Subject: Change of Manuals, Placards and Symbols

Effectivity: Sailplane TWIN ASTIR and TWIN ASTIR TRAINER
from Worksnumber 3001

Technical Information
TM 103 - 3

TWIN ASTIR
L - 315

Modified to Grob Technical Information TM 103 - 3
US TC NO G39EU

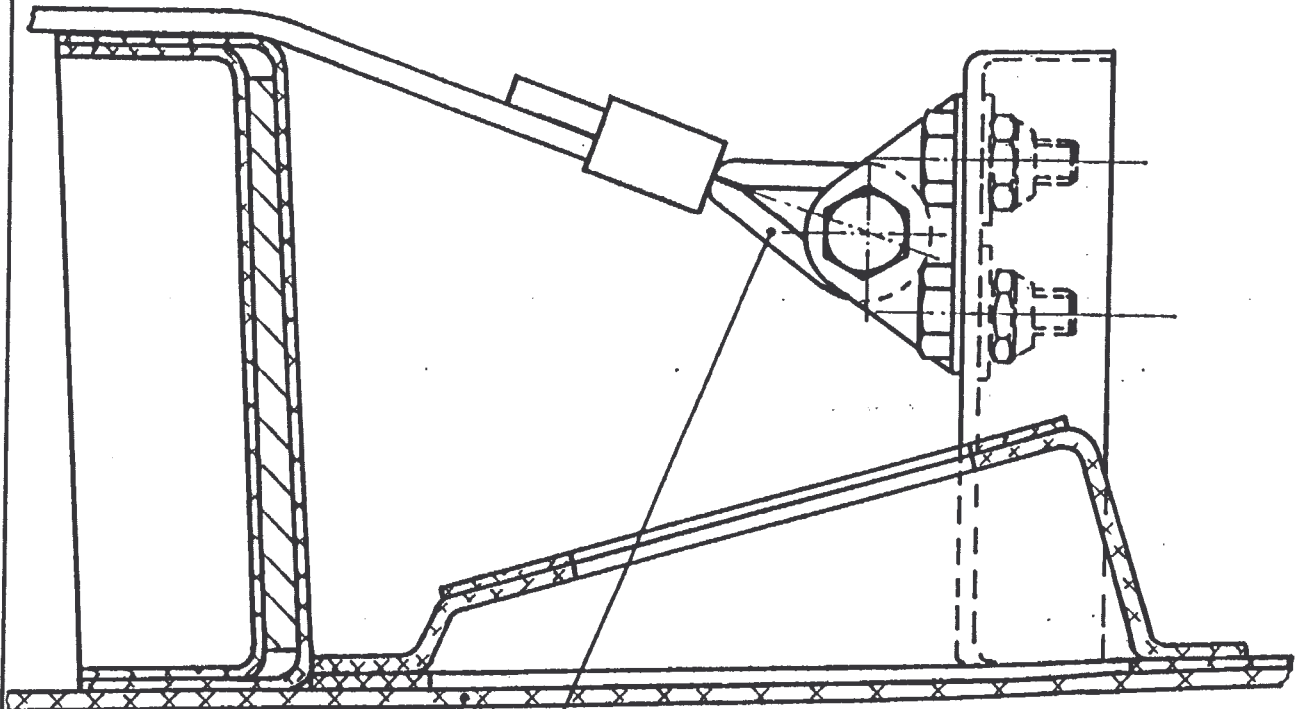
1. Flight Handbook TWIN ASTIR Published May 78
2. Maintenance Handbook TWIN ASTIR Published May 78
3. Repair Instructions TWIN ASTIR Published May 78
4. Placards shown on page 11 of the
Flight Handbook to place on the right
arm rest of front and rear cockpit
5. Placards shown on page 12 of the
Flight Handbook to place as remarked
6. Symbols shown on page 13 and 14 of
the Flight Handbook to place near
the corresponding lever or knob
7. The dataplate as shown below,
placed under the original typeplate
on the right fuselage frame.
